G.D. 15c

MEMORANDUM

To: Board of Regents
From: Board Office
Subject: Register of University of Northern Iowa Capital Improvement Business Transactions for Period of February 19, 2003, Through March 18, 2003
Date: March 31, 2003

Towers Center Improvements

Revised Ground Floor Schematic 4/03

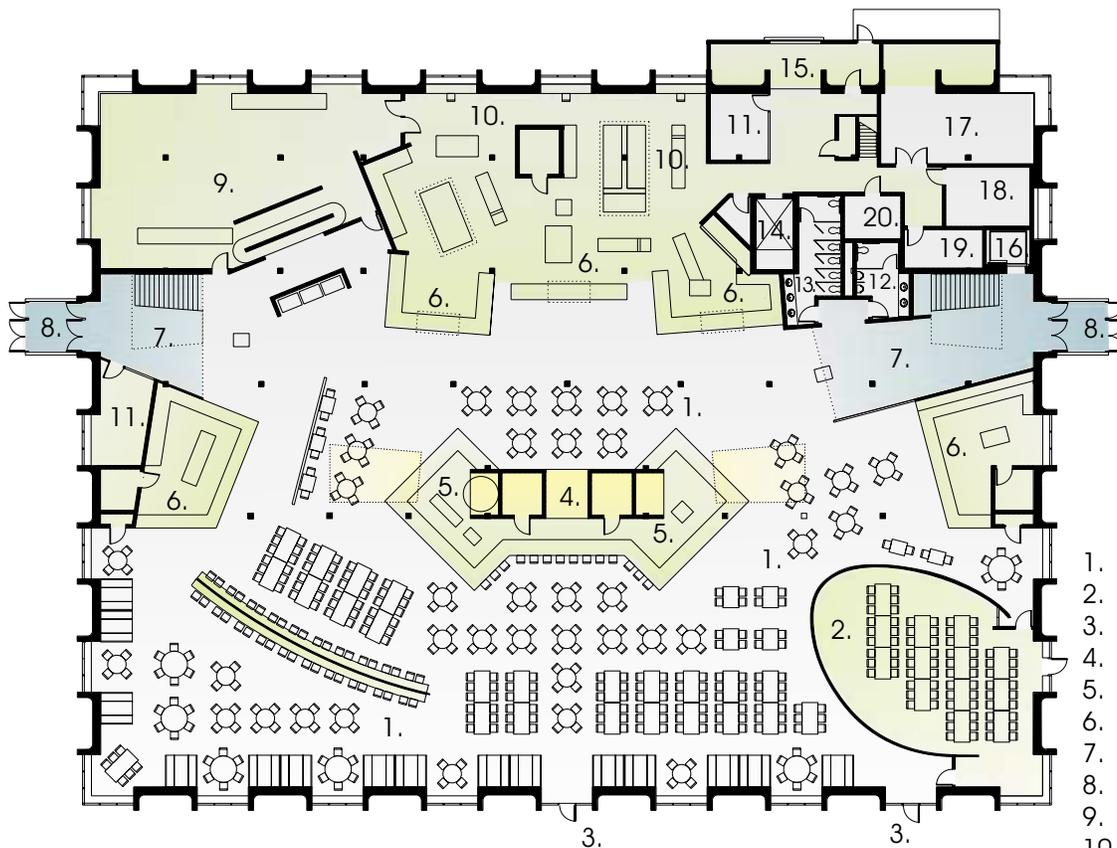
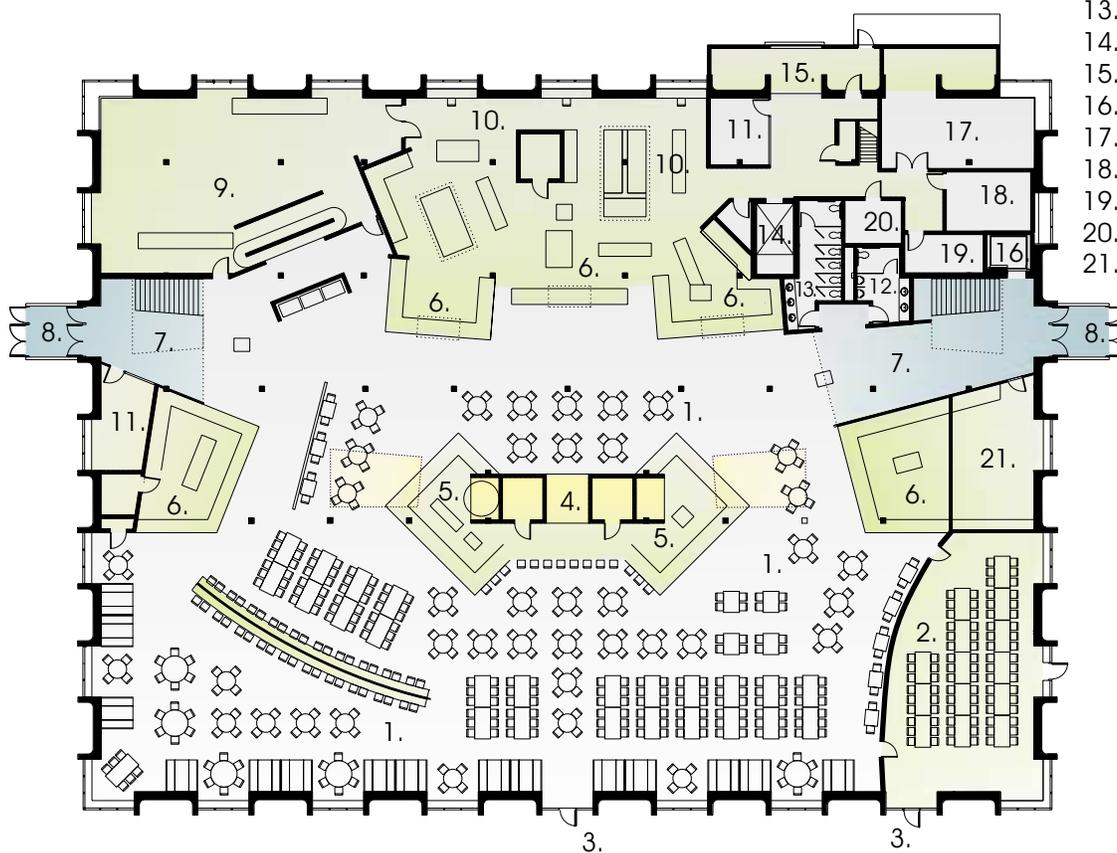
The revised schematic design includes the following modifications:

- The Grab 'n Go dining service has been relocated from the first floor to the ground floor (item 21 on the revised drawing).
 - The relocation of the Grab 'n Go service to the ground floor main dining level would provide functional and space efficiencies; this service would no longer require its own food production equipment (it would utilize the existing kitchen area on this level), which would reduce its space needs.
 - With the relocation of the Grab 'n Go dining service from the first floor, the modifications to the lounge, computer laboratory and study areas on this level have been reduced or eliminated.
- The private dining room on the ground floor (item 2 on the revised drawing) has been redesigned to accommodate the Grab 'n Go area and to provide space efficiencies while maintaining the seating capacity for the main dining area.
